Road Safety Audit Stage 1 Response Report

**FORD ENERGY
RECOVERY FACILITY
AND WASTE SORTING
AND TRANSFER
FACILITY, FORD
CIRCULAR TECHNOLOGY
PARK
STAGE 1 ROAD SAFETY
AUDIT RESPONSE
REPORT**

Report title	Stage 1 RSA Response Report
Date	25/03/2021
Document reference and revision	1620007830-001-RAM-XX-XX-RP-C-00001-Stage 1 RSA Response Report Rev P02
Prepared by	Ramboll UK Limited
On behalf of	Viridor Energy Limited, Grundon Waste Management Limited, Ford Energy from Waste Limited, West Sussex County Council

**APPENDIX 2
PROBLEM LOCATION PLAN**

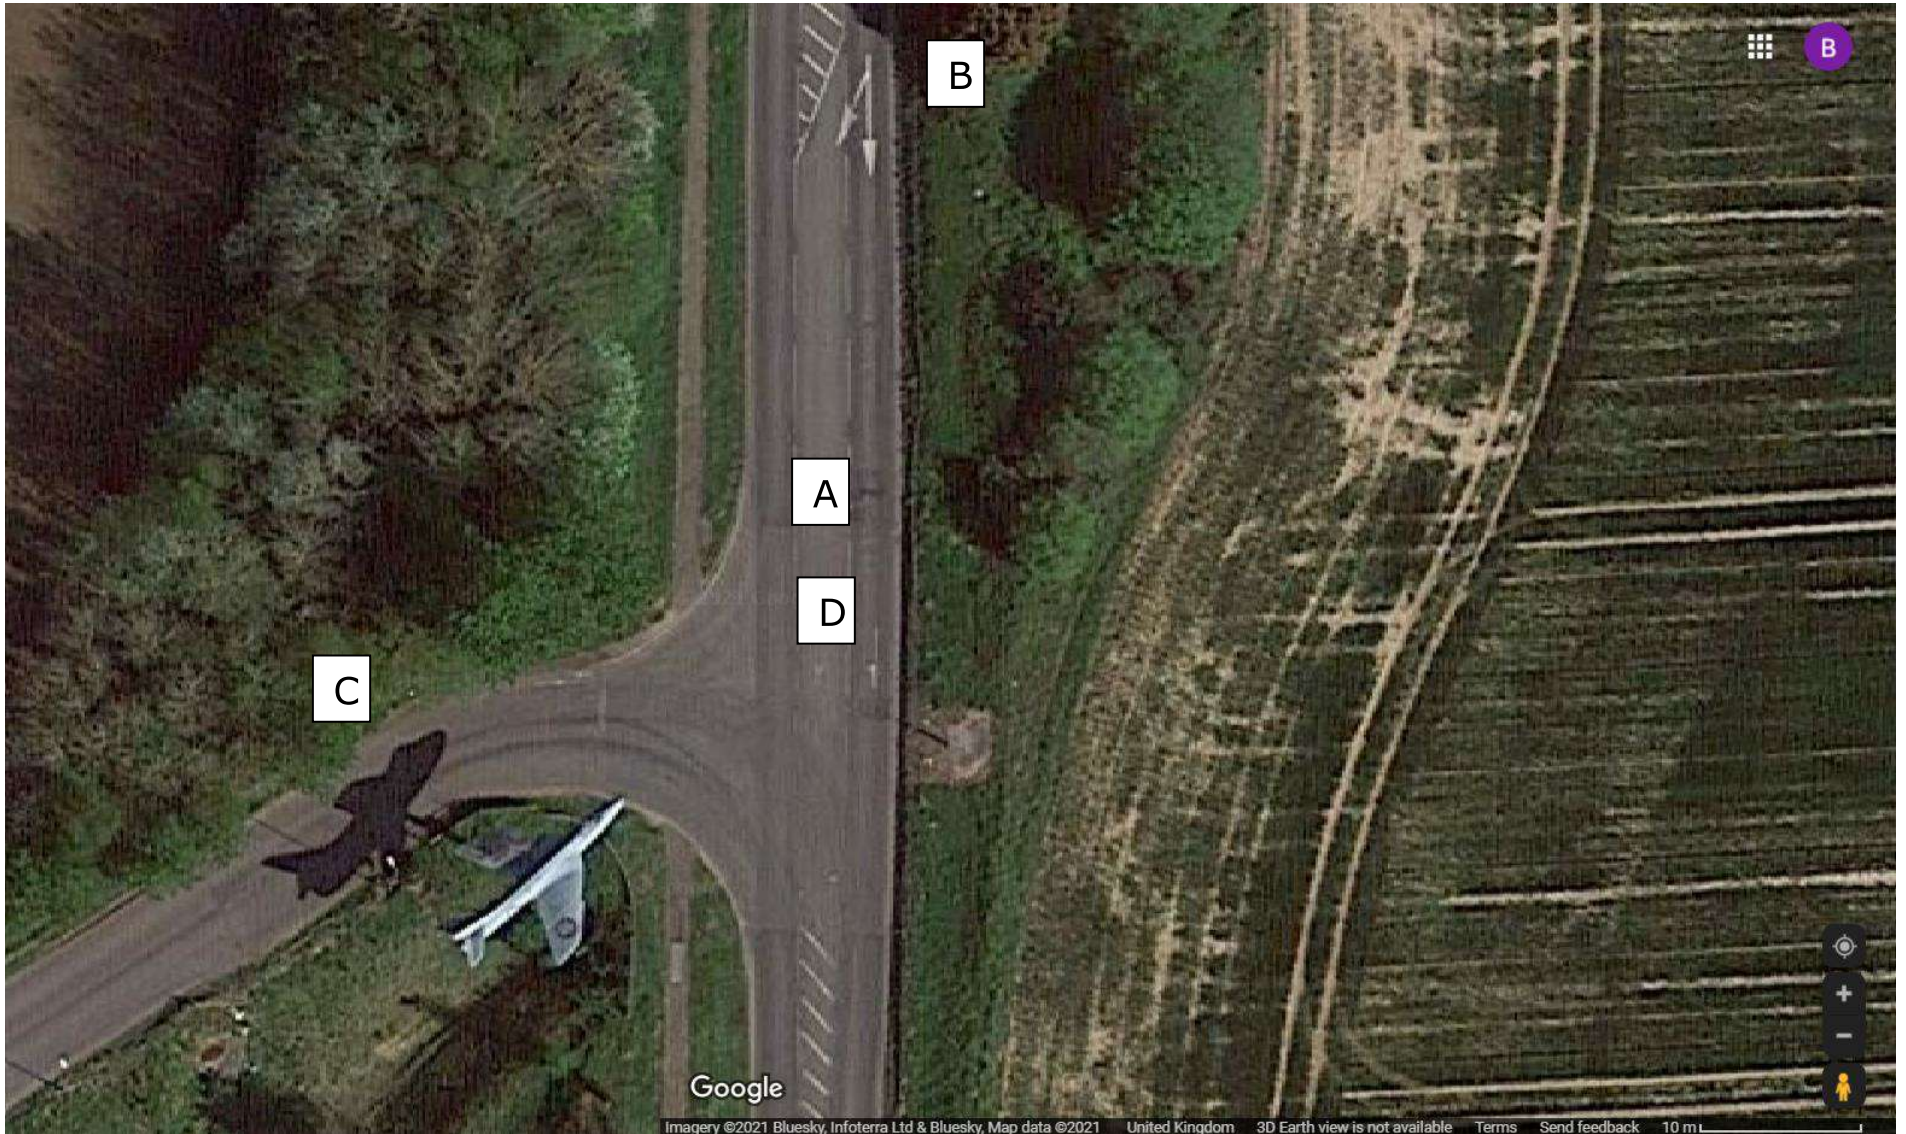
Location: On Ford Road within the junction (Location A on Plan in Appendix 2)

The existing road surface is damaged, within the junction, which may cause stability issues for Powered Two Wheelers (PTWs) especially. The damage will also lower the skid resistance for traffic generally in a braking area.

Location: East side of Ford Road (Location B on Plan in Appendix 2)

The existing VRS on the east verge of Ford Road at the junction, opposite the entrance to the site, is damaged and the non-compliant P4 terminal unit presents and launch opportunity for southbound errant vehicles due to a ramping effect.

Location: North channel of site access road (Location C on Plan in Appendix 2)

Despite the weather being sunny and warm with no obvious evidence of recent rain, during the site visit the Auditors noted ponding of water in the north channel of the site access road, close to the junction.

Location: Ford Road at Junction (Location D on Plan in Appendix 2)

RSA PROBLEM	RSA RECOMMENDATIONS	DESIGN ORGANISATION RESPONSE	OVERSEEING ORGANISATION RESPONSE	AGREED RSA ACTIONS
<p>Location On Ford Road within the junction (Problem Location A, Appendix A refers)</p> <p>Summary Existing damaged road surface presents low/variable skid resistance issues.</p> <p>Details The existing road surface is damaged, within the junction, which may cause stability issues for Powered Two Wheelers (PTWs) especially. The damage will also lower the skid resistance for traffic generally in a braking area. Loss of control in the braking/turning area may cause head-on or side-swipe type collisions resulting in casualties to PTW riders at the most serious.</p>	<p>Resurface carriageway over damaged areas to prevent identified collisions.</p>	<p>The resurfacing of Ford Road is within the remit of maintenance work undertaken by West Sussex County Council and the Designer requests WSCC to share its forward programme of pavement renewals to assist in responding to the RSA recommendation.</p>

RSA PROBLEM	RSA RECOMMENDATIONS	DESIGN ORGANISATION RESPONSE	OVERSEEING ORGANISATION RESPONSE	AGREED RSA ACTIONS
<p>Location East side of Ford Road (Problem Location B, Appendix A refers)</p> <p>Summary Existing damaged VRS non-compliant and presents a launch opportunity due to ramping</p> <p>Details The existing VRS on the east verge of Ford Road at the junction, opposite the entrance to the site, is damaged and the non-compliant P4 terminal unit presents a launch opportunity for southbound errant vehicles due to a ramping effect.</p> <p>The types of collisions that may occur are vehicle overturning, especially those travelling southbound at speed. Such overturning vehicle collisions are likely to result in casualties with grave consequences.</p>	<p>Install a compliant terminal to the VRS to prevent identified collisions. Repairs to the damaged VRS should be undertaken.</p>	<p>It is understood that a compliant terminal installation is the responsibility of West Sussex County Council, and a replacement should be provided at the end of life. The Designer requests WSCC to share its forward programme of barrier renewals to assist in responding to the RSA recommendation.</p>

RSA PROBLEM	RSA RECOMMENDATIONS	DESIGN ORGANISATION RESPONSE	OVERSEEING ORGANISATION RESPONSE	AGREED RSA ACTIONS
<p>Location North channel of site access road (Problem Location C, Appendix A refers)</p> <p>Summary Ponding of water encroaching onto carriageway</p> <p>Details Despite the weather being sunny and warm with no obvious evidence of recent rain, during the site visit the Auditors noted ponding of water in the north channel of the site access road, close to the junction.</p> <p>The types of collisions that may occur if vehicles encounter such ponding is loss of control, either due to water in spring, summer or autumn, or due to ice in winter.</p>	<p>Install drainage system to deal with surface run-off and discharge away from road and nearby footway.</p>	<p>It is likely this issue is related to maintenance of roadside drainage systems (a blocked gully, an outlet silted up, etc.). The Designer requests WSCC to share its forward programme of drainage renewals to assist in responding to the RSA recommendation. If the drainage system in question is not owned by WSCC, the Designer will request the appropriate landowner to attend to the maintenance required.</p>

RSA PROBLEM	RSA RECOMMENDATIONS	DESIGN ORGANISATION RESPONSE	OVERSEEING ORGANISATION RESPONSE	AGREED RSA ACTIONS
<p>Location Ford Road at Junction (Problem Location D Appendix A refers)</p> <p>Summary Carriageway marking generally illegible</p> <p>Details The Auditors noted that ghost-island carriageway markings on Ford Road were generally illegible.</p> <p>Illegible carriageway markings could lead to badly positioned turning vehicles resulting in head-on collisions on Ford Road, particularly during hours of darkness. The types of casualties that may occur are likely to be in-vehicle occupants.</p>	<p>Refresh the carriageway markings to guide drivers to take up correct positioning at the junction.</p>	<p>This is understood to be within the remit of maintenance work to be undertaken by West Sussex County Council and the Designer requests WSCC to share its forward programme of road marking renewals to assist in responding to the RSA recommendation.</p>

Resurface carriageway over damaged areas to prevent identified collisions.

Install a compliant terminal to the VRS to prevent identified collisions. Repairs to the damaged VRS should be undertaken.

Install drainage system to deal with surface run-off and discharge away from road and nearby footway.

Refresh the carriageway markings to guide drivers to take up correct positioning at the junction.
